CROSSROADS MIXED USE FILING NO. 1

COUNTY OF EL PASO, STATE OF COLORADO STORM SEWER PLANS

UNDERGROUND DETENTION
DECEMBER 2022

SITE MAP
N.T.S.

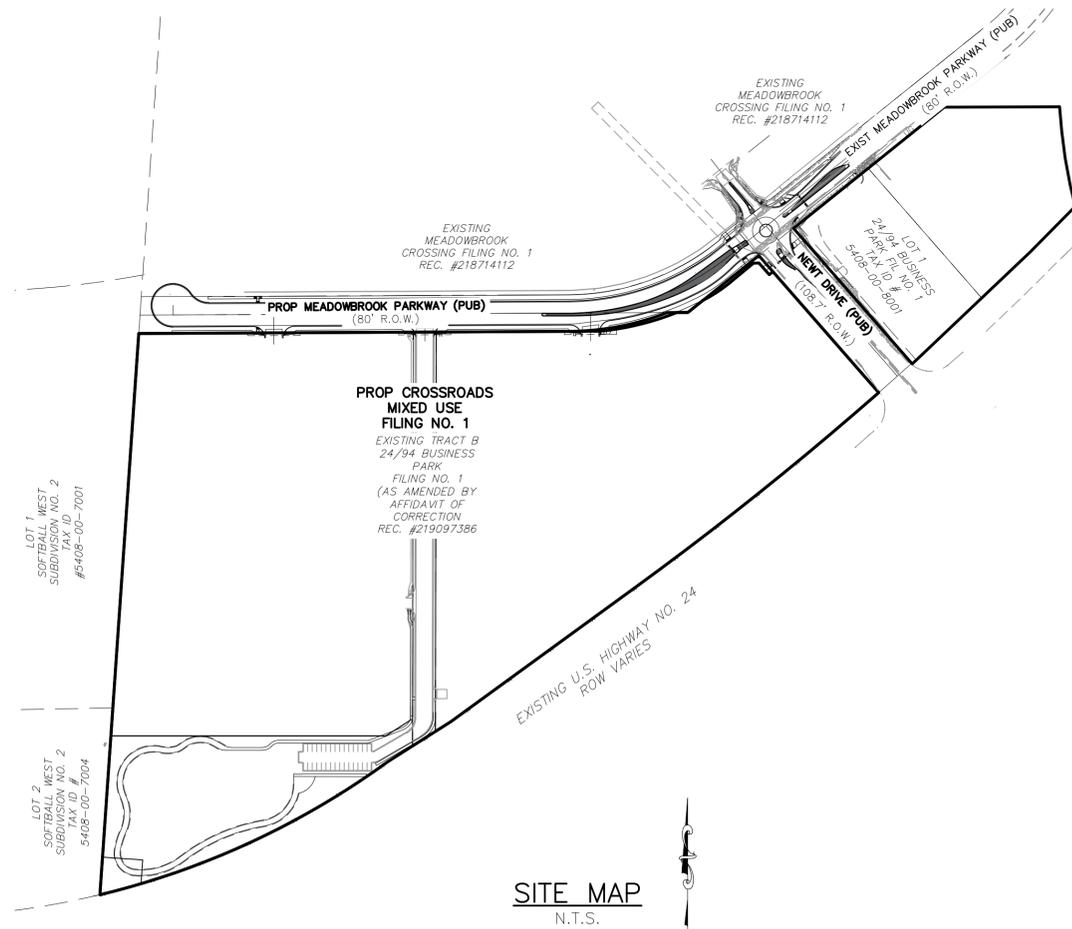
Provide an updated grading and erosion control plan

ST02

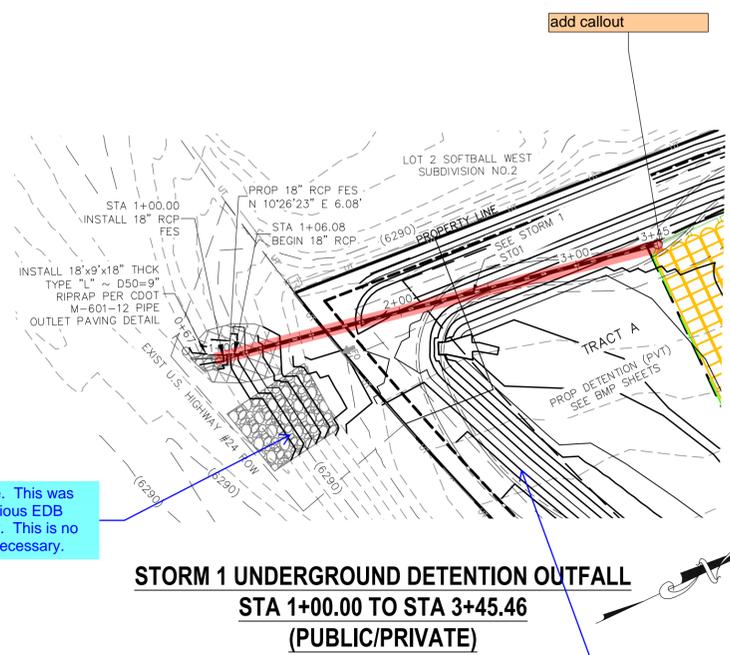
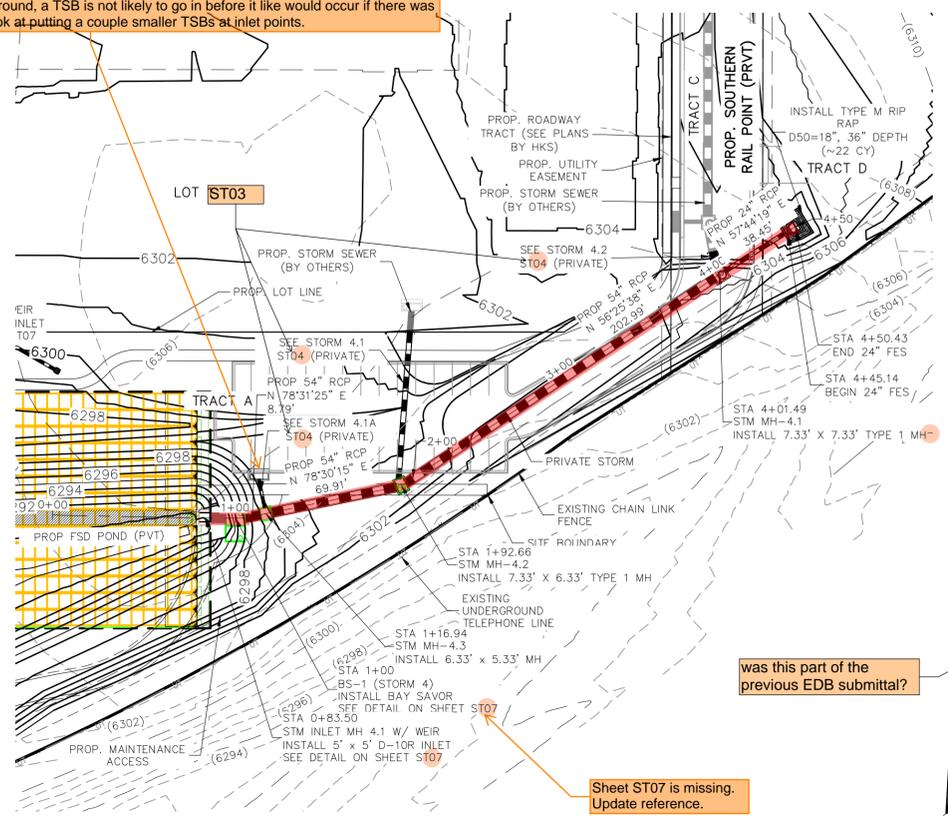
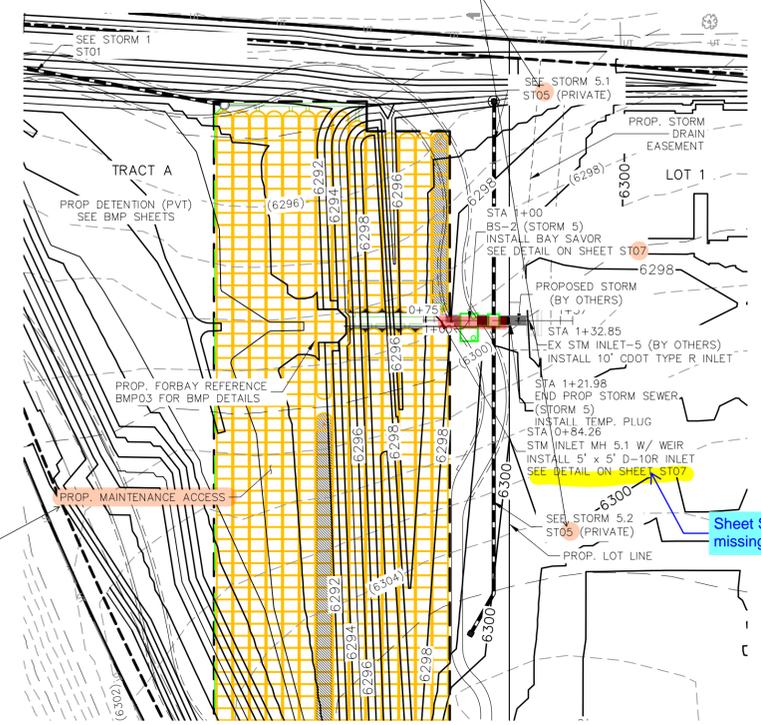
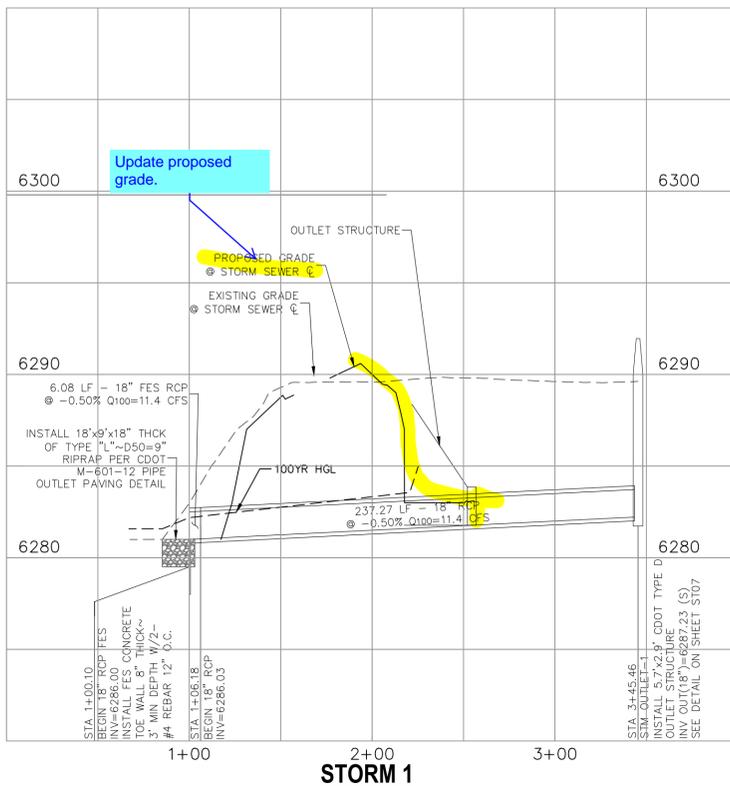
Provide a detail of the whole pond area and all surrounding SW piping, like the one shown on the last page of the Drainage Letter (page 44 of 44)

Include callout for pet waste station(s) around the park/pond, with signage stating that pet waste must be picked up.

Having sufficient BMPs upstream of the pond (like inlet protection) will be crucial to keeping the UGD system from getting inundated with sediment once the UGD system is installed but the tributary basins are still being developed and without sufficient vegetation. This is more important for UGD systems than above ground ponds, because it is more difficult to get sediment out of UGD systems. Especially if a bigger storm occurs during construction that causes untreated runoff to bypass the isolator rows via the manifold, as there is no easy way to remove sediment from the non-isolator rows. Also, because the system is now below ground, a TSB is not likely to go in before it like would occur if there was going to be an above ground pond. So look at putting a couple smaller TSBs at inlet points.

Remove. This was the previous EDB Spillway. This is no longer necessary.

Update proposed contours to reflect the updated design.

was this part of the previous EDB submittal?

CROSS ROAD MIXED USE FILING NO. 1
STORM SEWER PLANS
PROJECT NO. 18-003
SCALE: HORIZONTAL: 1"=50' VERTICAL: 1"=5'
DATE: 12-23-22
DESIGNED BY: GT
DRAWN BY: TAU
CHECKED BY: VAS
SHEET 3 OF 6
ST03

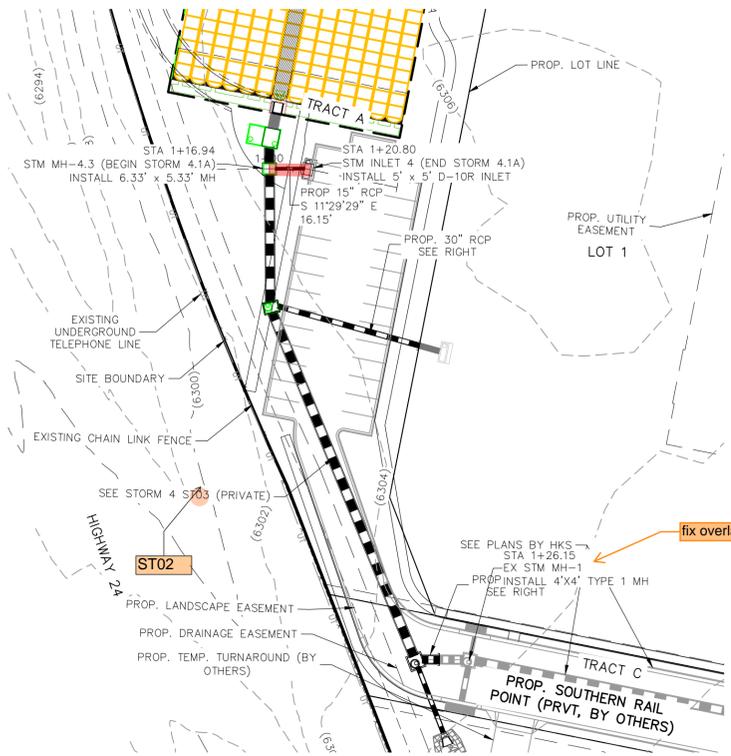
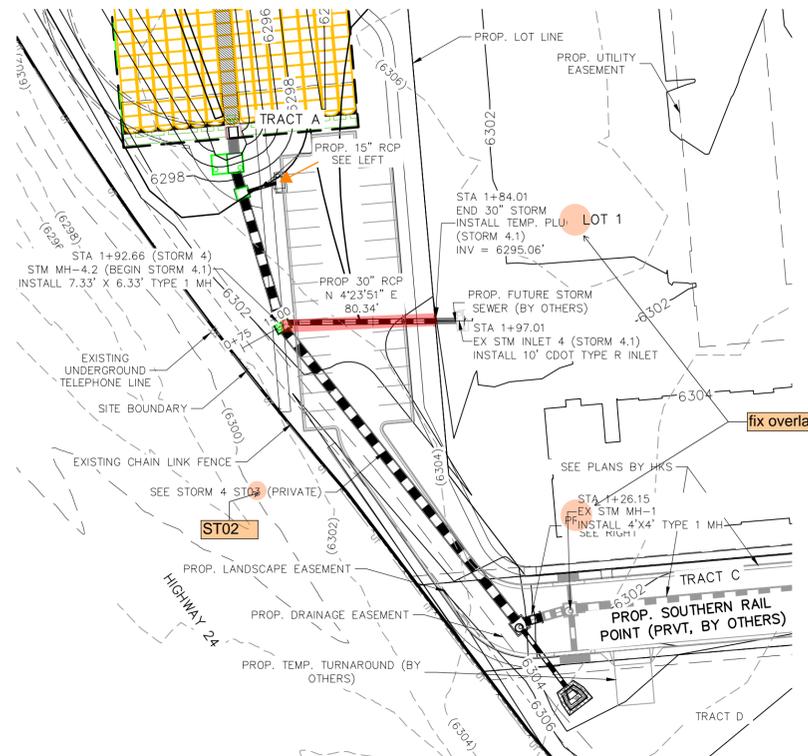
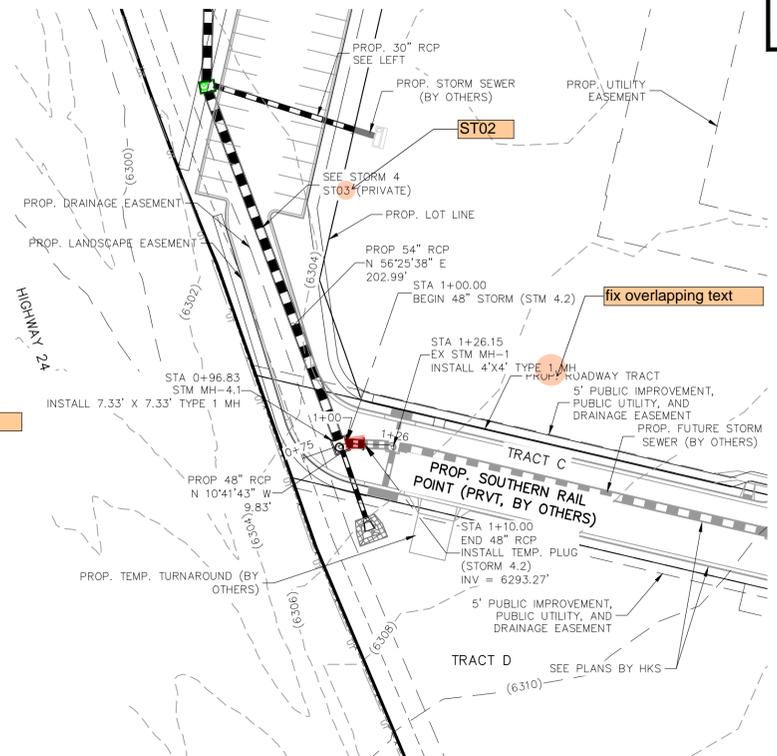
Drainage letter identified this as future parking overflow.
Revise design. An interim drainage solution should be presented. The final configuration with the D-10R inlet should be a part of the parking lot site plan approval.

CONCEPTUAL LAYOUT

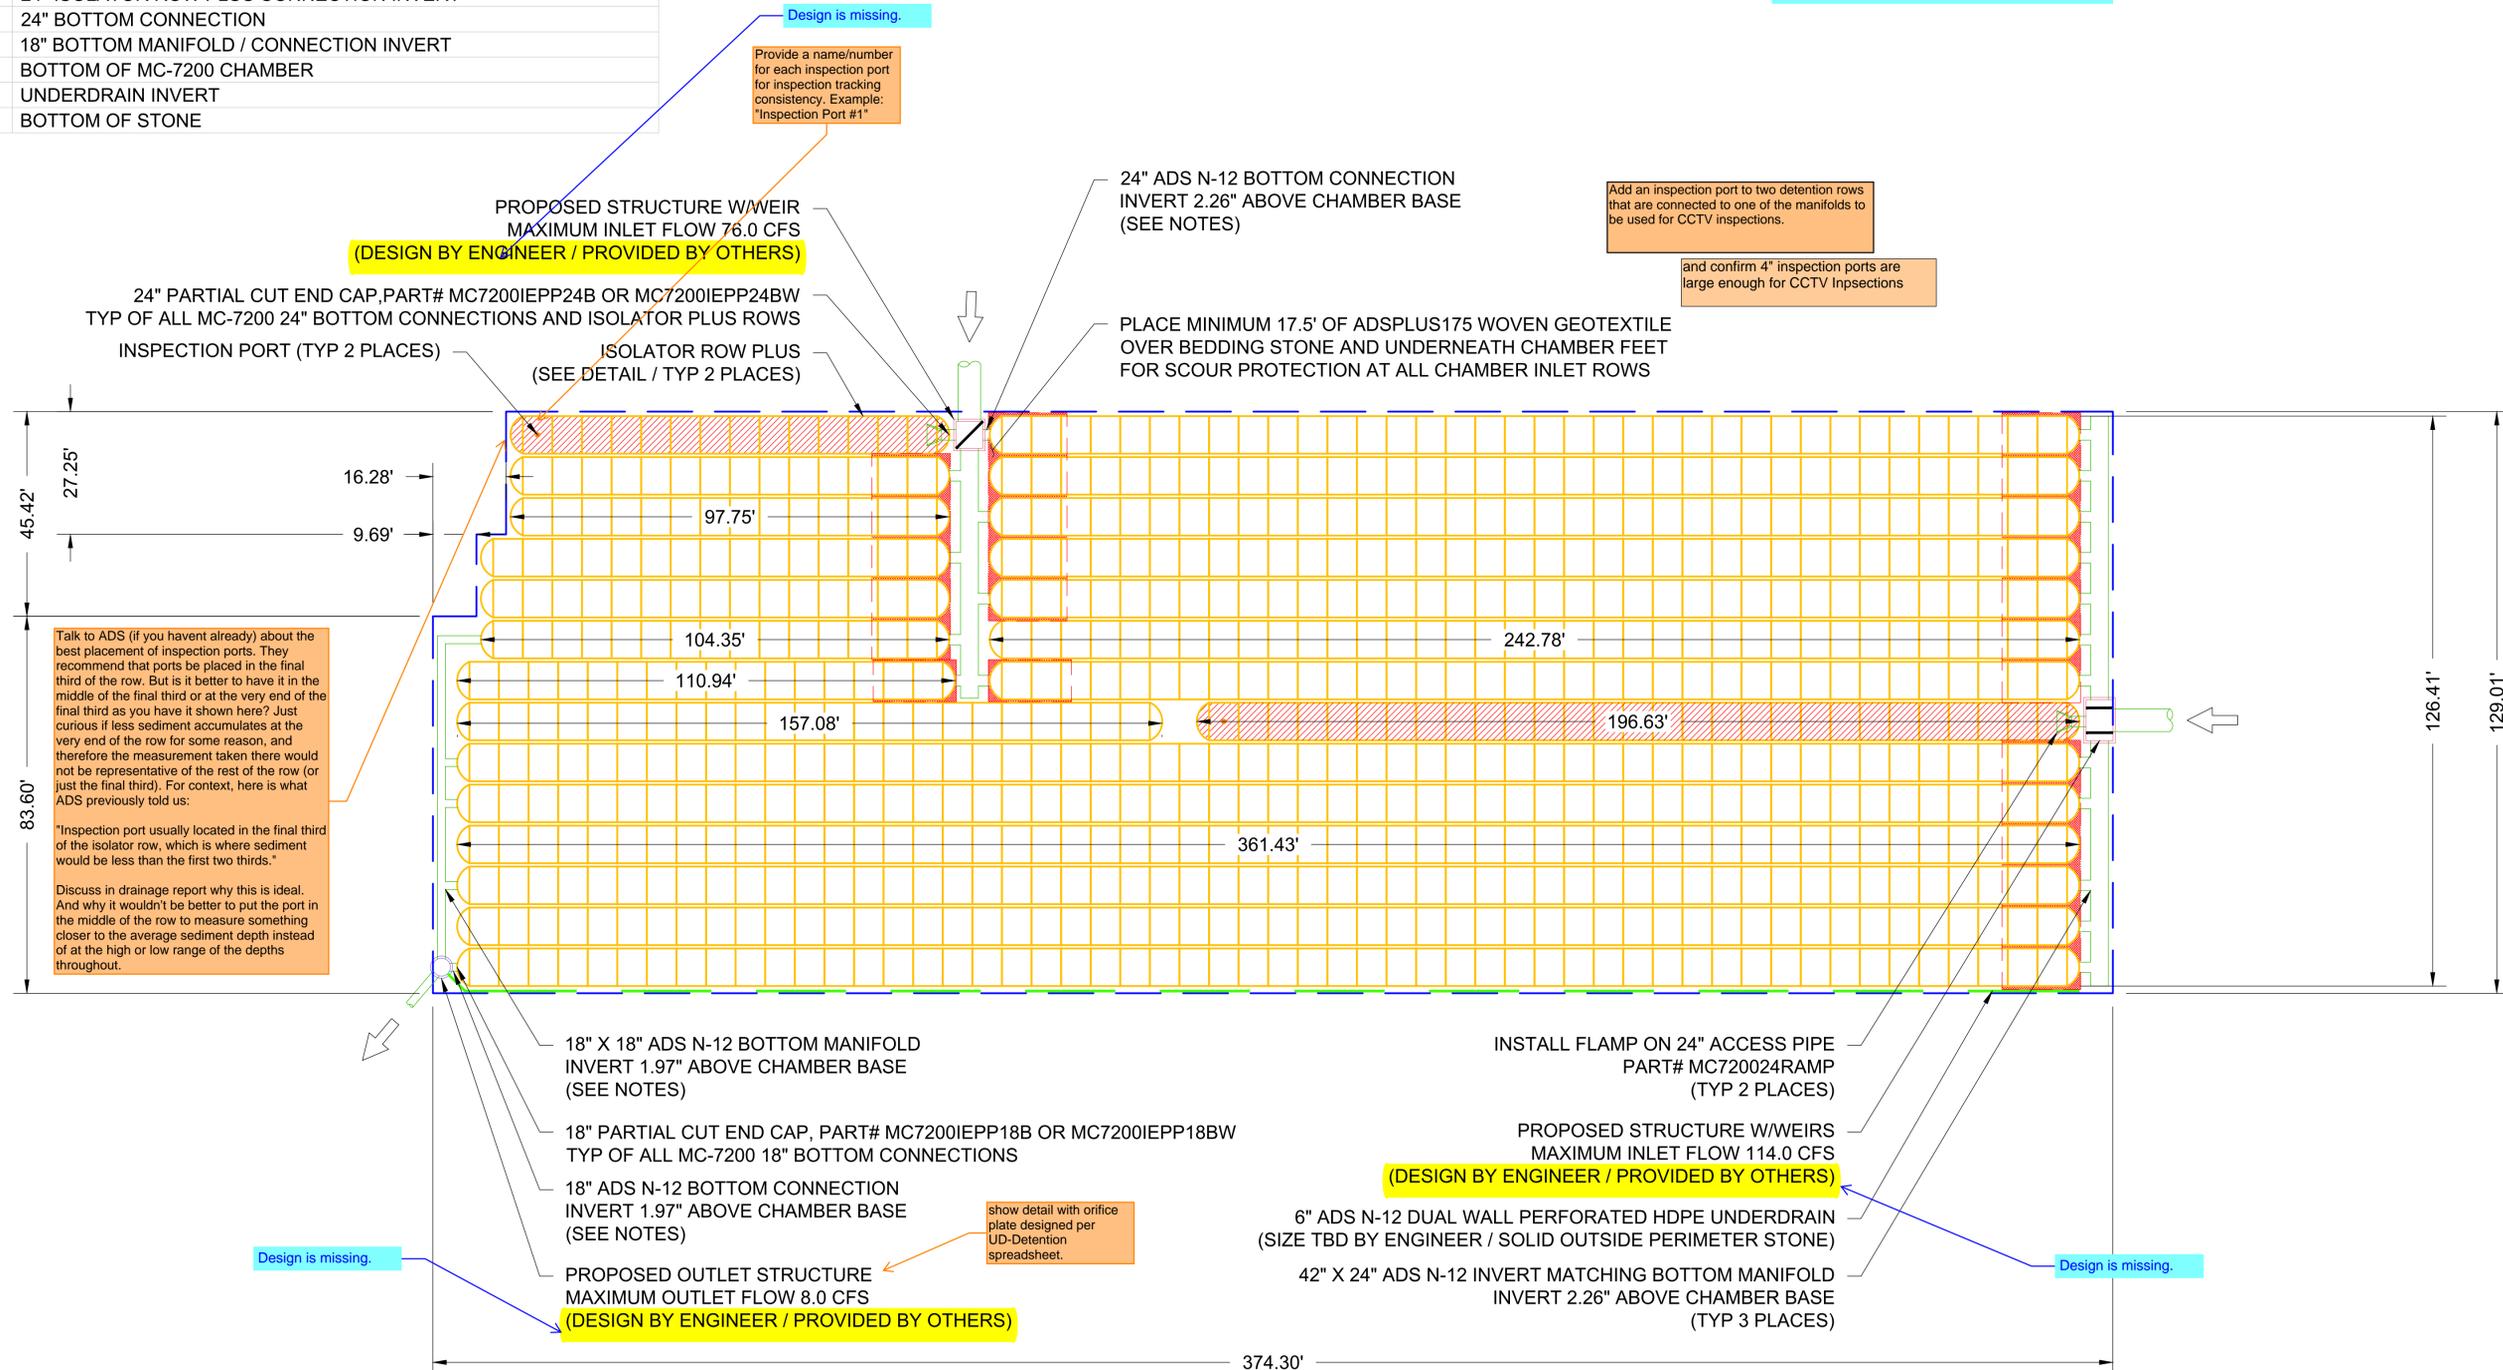
Provide the geotech analysis that addresses this note.

The plans need to be updated to reflect the required base stone depth.

Design is missing.

Provide a name/number for each inspection port for inspection tracking consistency. Example: "Inspection Port #1"

Add an inspection port to two detention rows that are connected to one of the manifolds to be used for CCTV inspections.

show detail with orifice plate designed per UD-Detention spreadsheet.

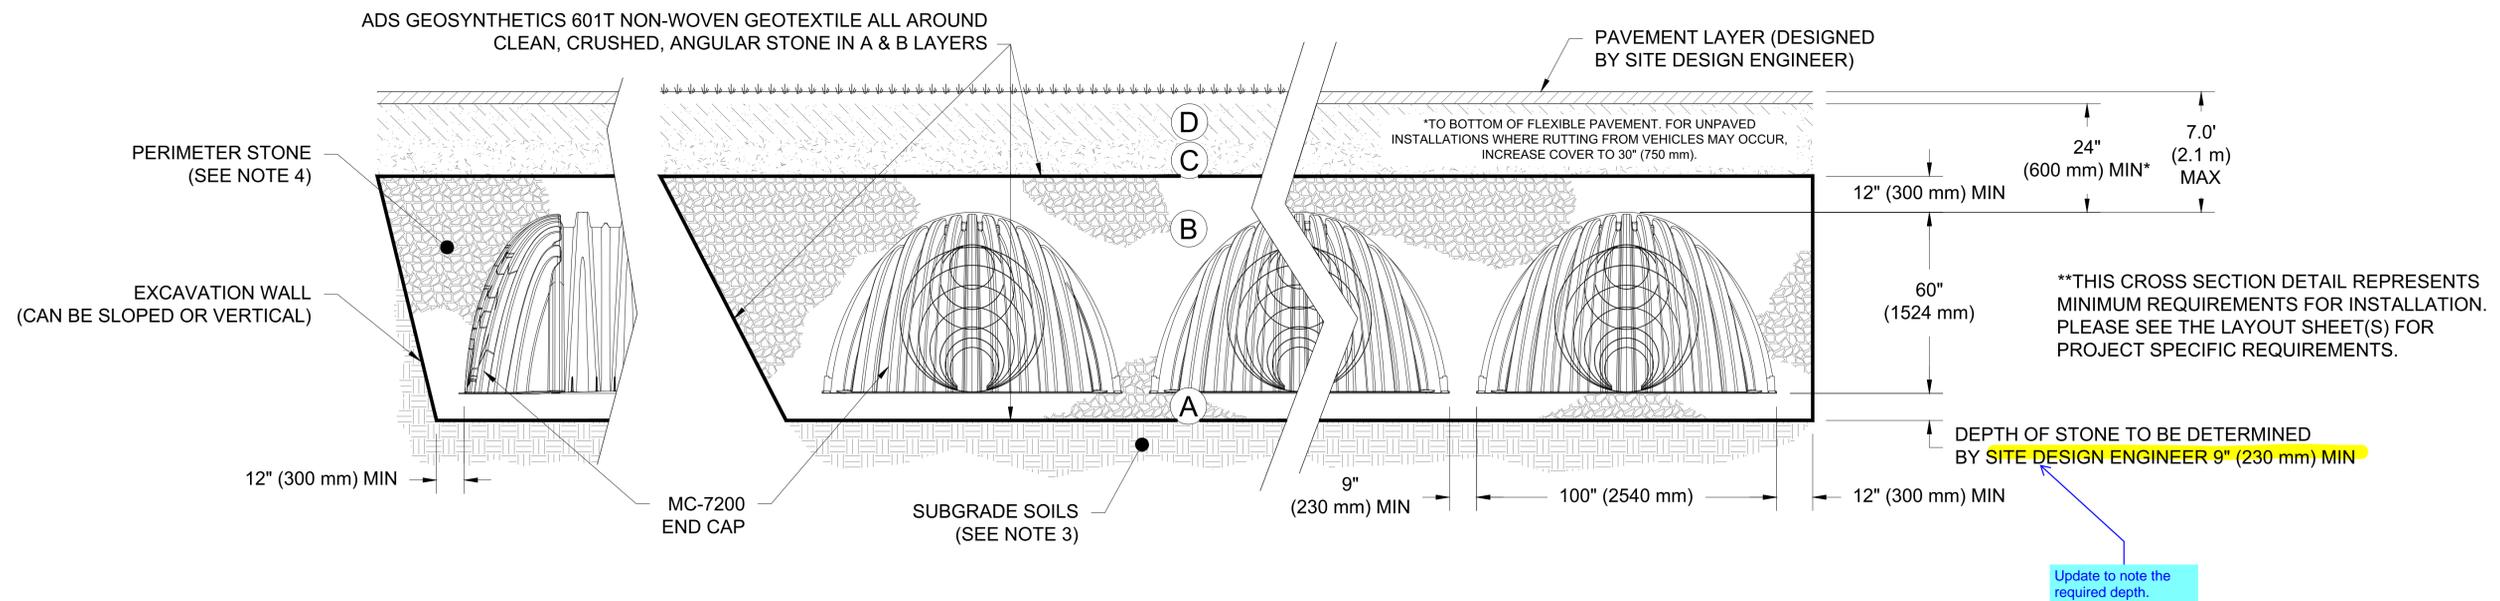
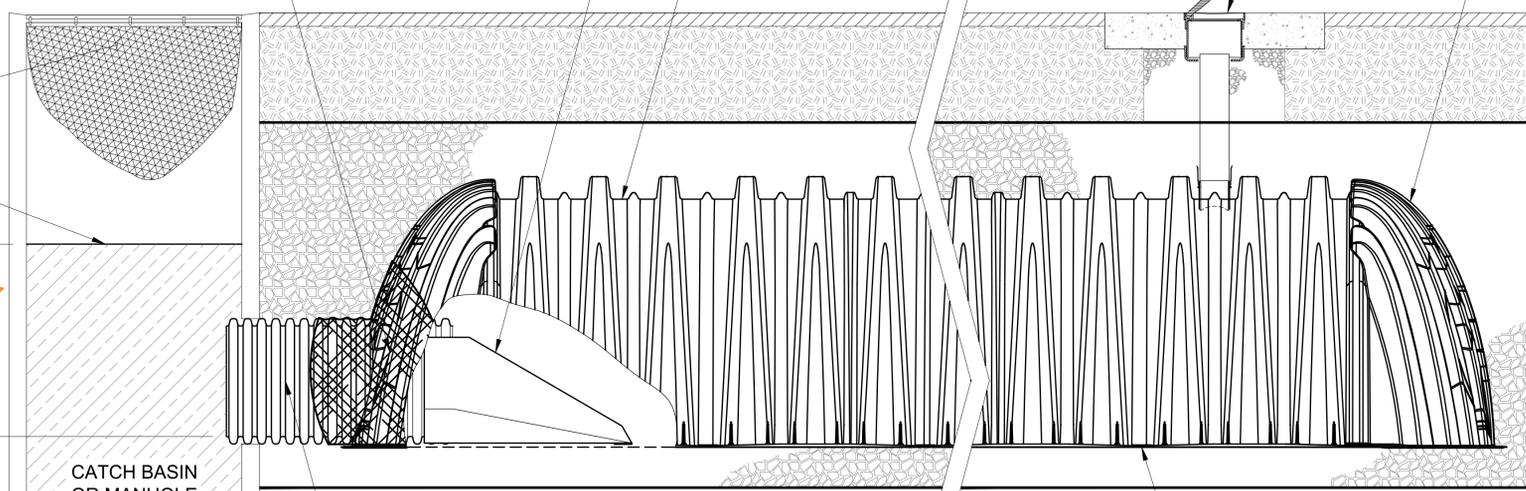
Update note and detail with the actual design. The note is ambiguous in nature. If Flexstorm inserts are to be installed then identify on the construction plans, drainage report, and O&M Manual.

Update to provide the reference detail/sheet.

Update to actual required depth.

Provide access stairs.

For outlet structure detail (once provided):
Look at need to upsize outlet structure so that there is space for personnel to do maintenance around trash rack and/or orifice plate.
